# Pretreatment Compliance Audit

## Final Summary Report

**Discharger:** Malaga County Water District  
NPDES Permit No. CA0084239  
Order No. R5-2008-0033

**Audit Dates:** January 6–7, 2014

**Attachment 2  
Fresno Truck Wash  
Piping and Instrumentation Diagram/Drawing  
for the Pretreatment System**

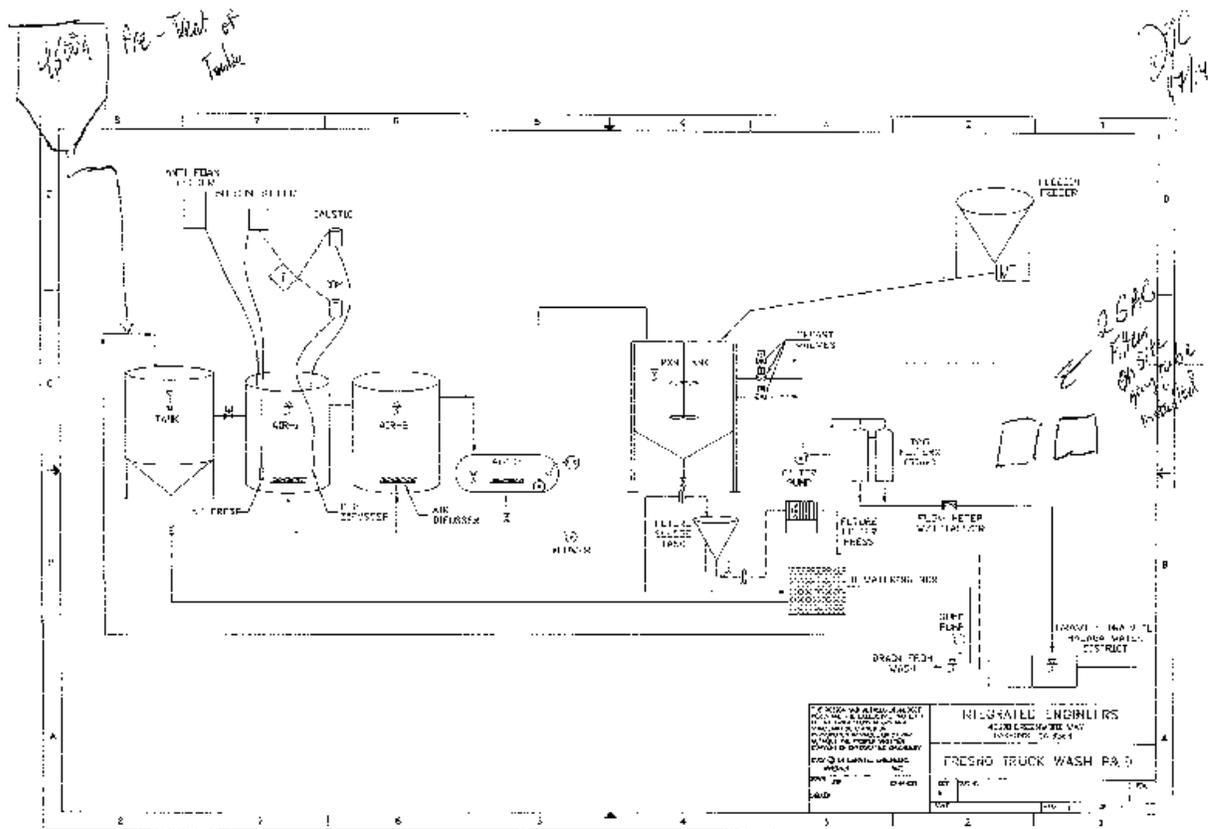
The piping and instrumentation diagram/drawing (P&ID) that the facility provided to the inspection team did not depict the 4,500 gallon batch treatment tank or solids management equipment (pump, piping, or drying beds) that were observed during the site inspection. It is recommended that the District conduct a follow up inspection at the facility to review and accurately depict the pretreatment system and sewer discharge locations in a facility diagram.

10. The piping and instrumentation diagram/drawing (P&ID) that the Fresno Truck Wash facility provided to the inspection team did not depict the 4,500 gallon batch treatment tank or solids management equipment (pump, piping, or drying beds) that were observed during the site inspection. It is recommended that the District conduct a follow up inspection at the facility to review and accurately depict the pretreatment system and sewer discharge locations in a facility diagram. (Section 9.3, Nondomestic Discharger Site Inspections Conducted during the Audit)

**Photograph 3.** Photograph of the paper filter unit. Wastewater flows through the paper which removes glues and general debris. Note the bypass valving. The valving is positioned to treat wastewaters.

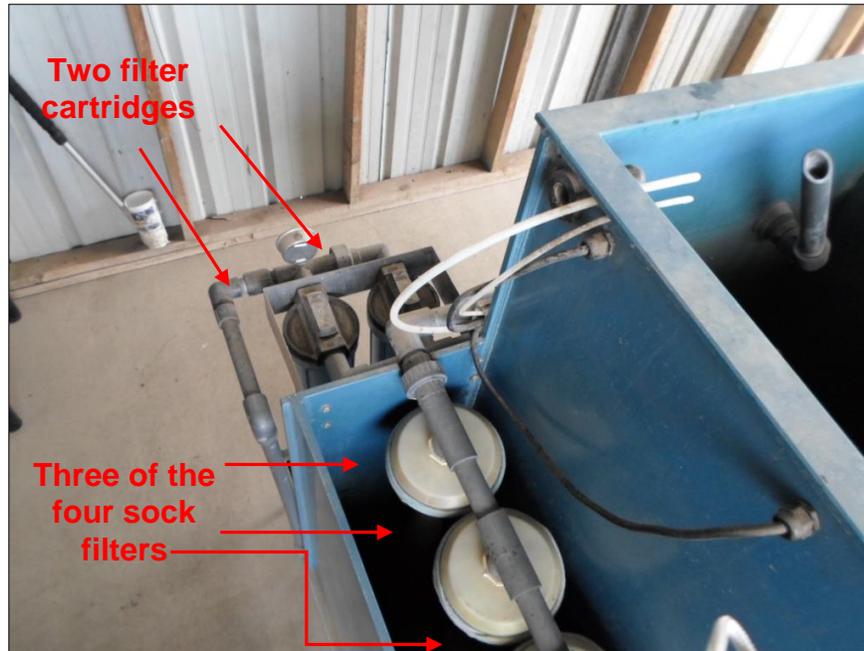
3. The paper filter unit had piping valves in two locations which would allow this unit to be bypassed (refer to photo 3 of the attached photograph log). The valves were positioned at the time of the inspection to deliver wastewaters to the paper filter. The facility representatives stated that they do not use the bypass valving and would remove the valves if requested. The audit team strongly recommends that the District have the facility remove or lock out the bypass valve. If the bypassing capabilities are required for certain operating and maintenance conditions, then a written standard operating procedure shall be developed so that the pretreatment and quality of wastewater are not compromised.

12. The paper filter unit had piping valves in two locations which would allow this unit to be bypassed at the Greentec facility. The valves were positioned at the time of the inspection to deliver wastewaters to the paper filter. The facility representatives stated that they do not use the bypass valving and would remove the valves if requested. The audit team strongly recommends that the District have the facility remove or lock out the bypass valve. If the bypassing capabilities are required for certain operating and maintenance conditions, then a written standard operating procedure shall be developed so that the pretreatment and quality of wastewater are not compromised. (Section 9.3, Nondomestic Discharger Site Inspections Conducted during the Audit)
